**ADDENDUM TO RFP DOCUMENTS**

ADDENDUM # 03
	SCCD RFP: # 14-014
	Project: Solano Community College District Theater Renovation
	Date: 08/13/2015

**Addendum # 03 – The following clarifications are provided based on questions received and must be added/considered when completing your submittal:** Acknowledgement of receipt of this **ADDENDUM** is required in the proposal’s cover letter of introduction. Please clearly note the addendum date and number.

**M2.2**

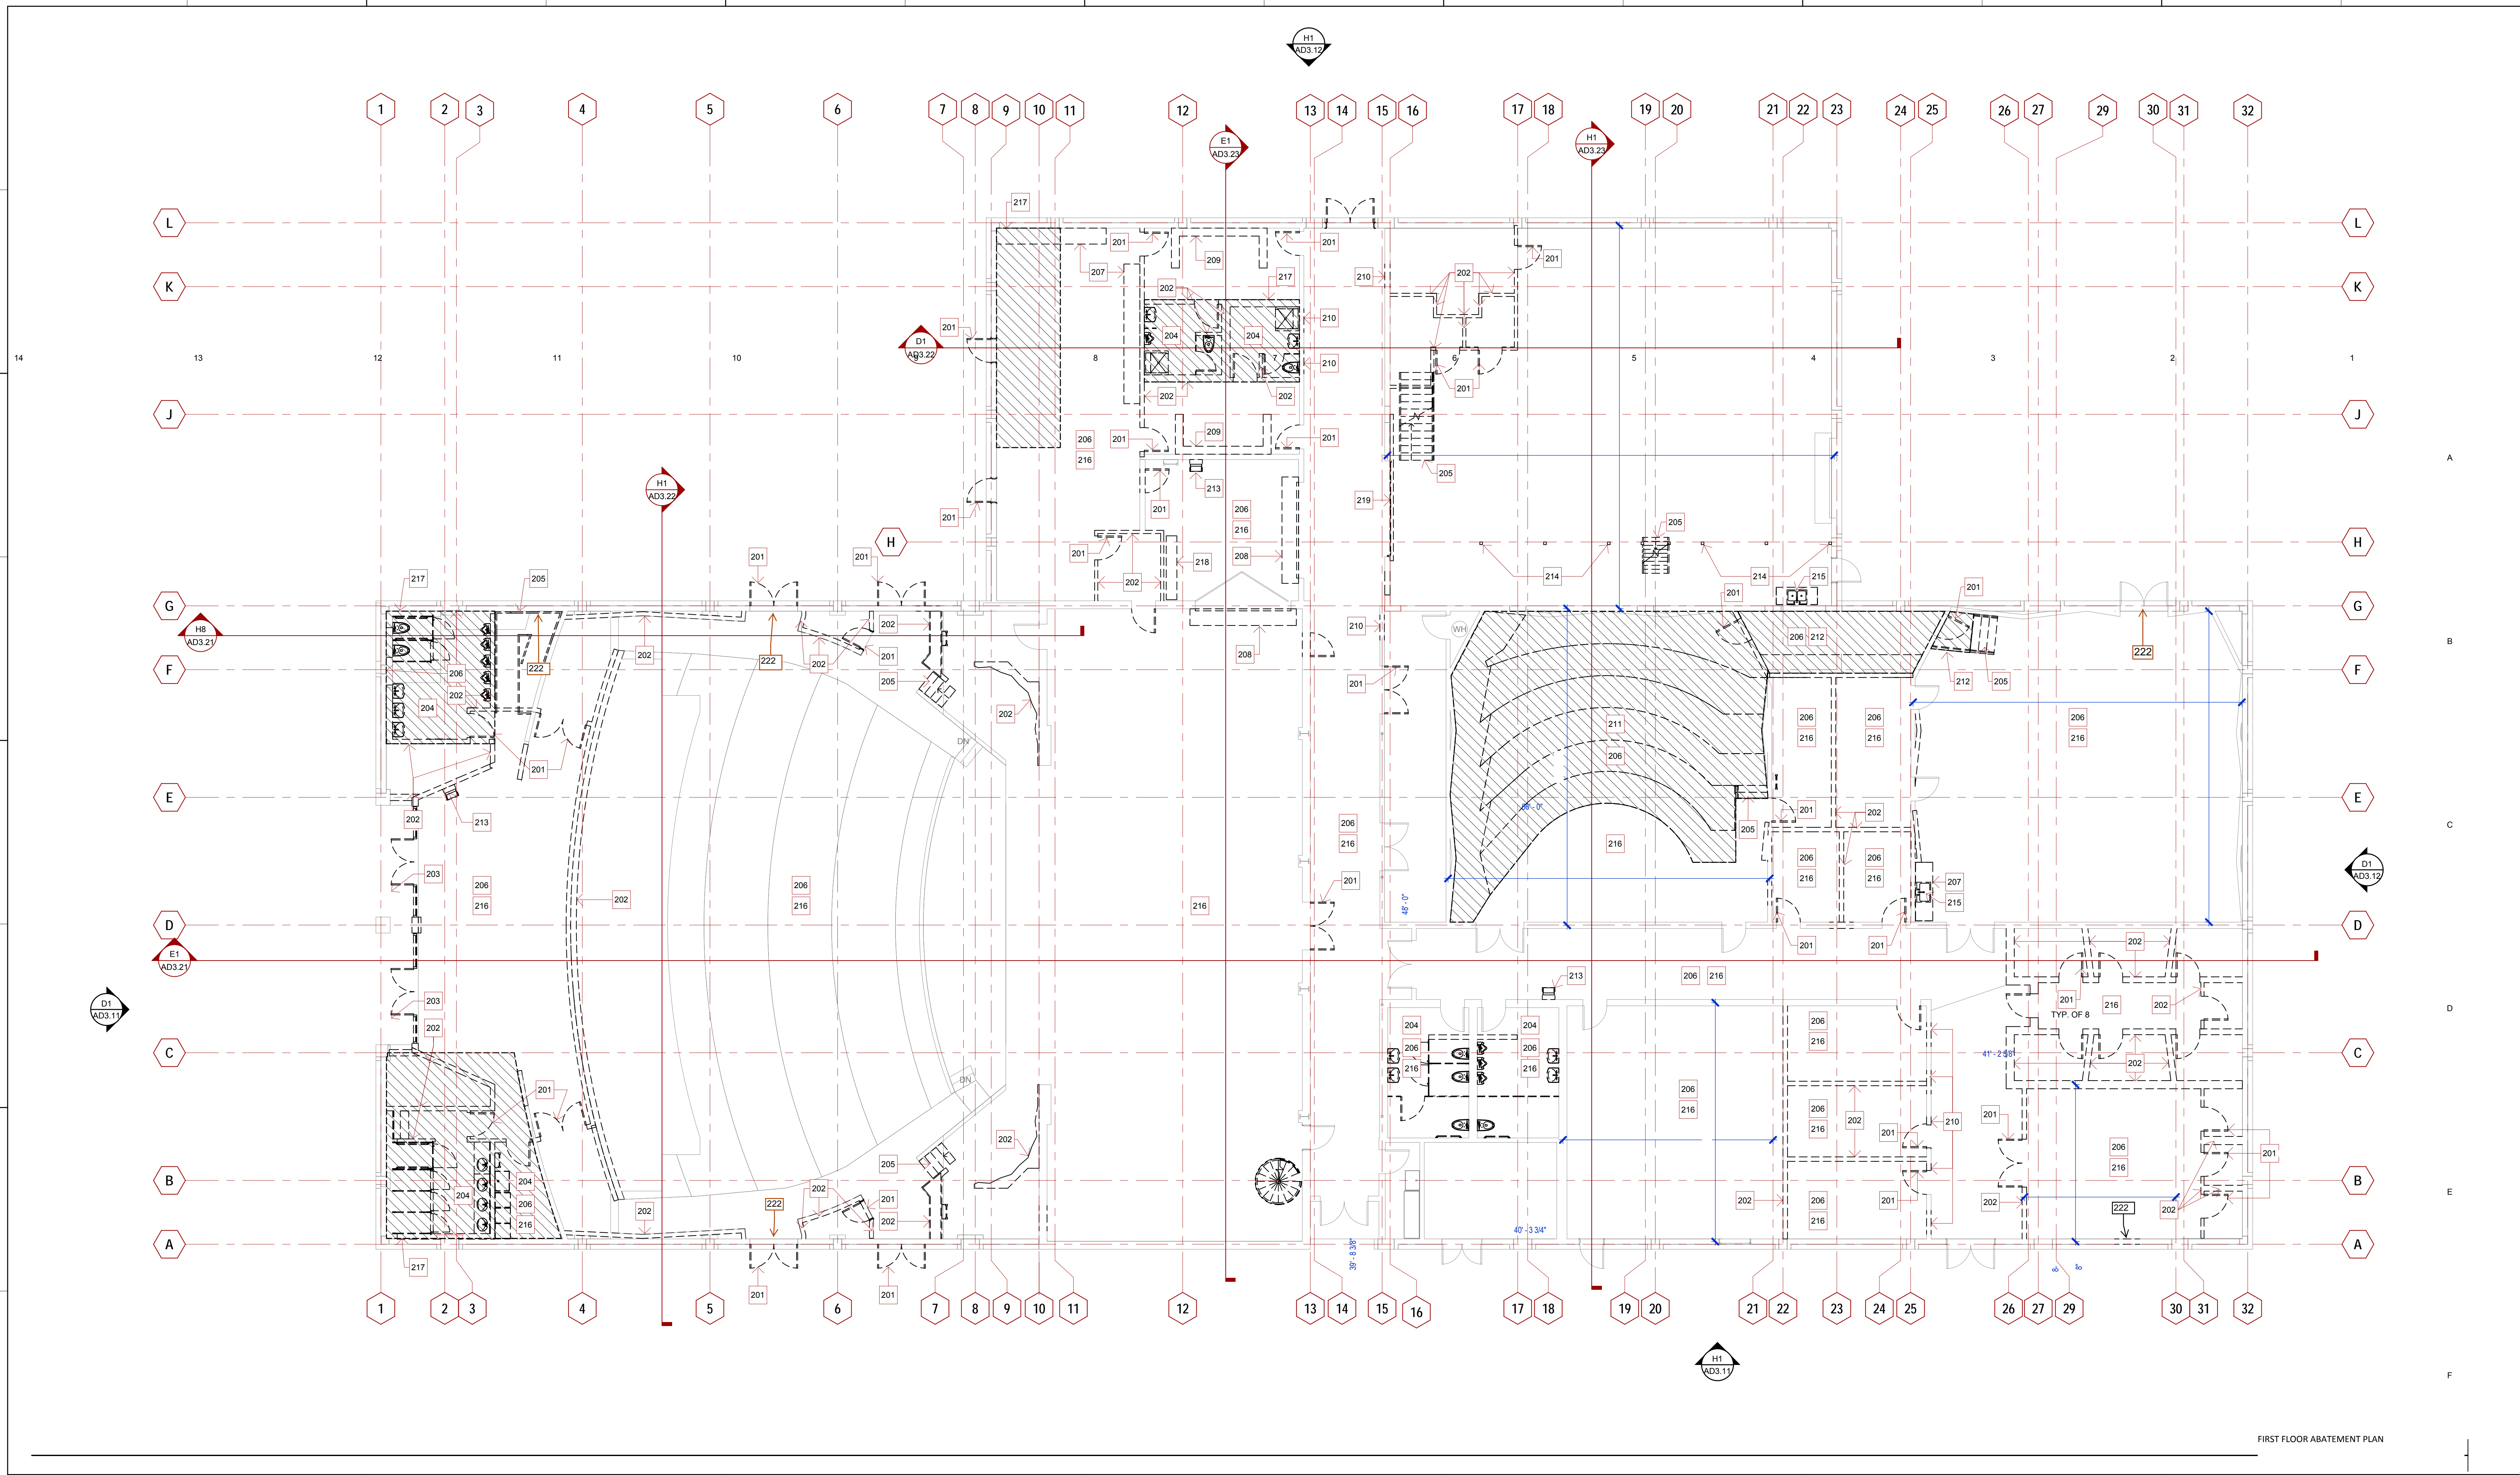
- a. On Drawing M2.2 along column line C1, between 29 and 30 there is a 12 x 12 duct passing through a rated wall. This ductwork does not have a FSD designation. Please confirm no FSD is required at this ductwork.  
Response: The FSD is shown on the addendum 2 drawings.
- b. On Drawing M2.2 along column line 25, between A and A there is a 10 x 10 duct passing through a rated wall. This ductwork does not have a FSD designation. Please confirm no FSD is required at this ductwork.  
Response: Yes, the 10x10 will have an FSD, it will be shown on addendum 3.
- c. We have been unable to find sound trap tagged ST-10. Please confirm it is not required or provide location.

Response: The ST-10 is not required.
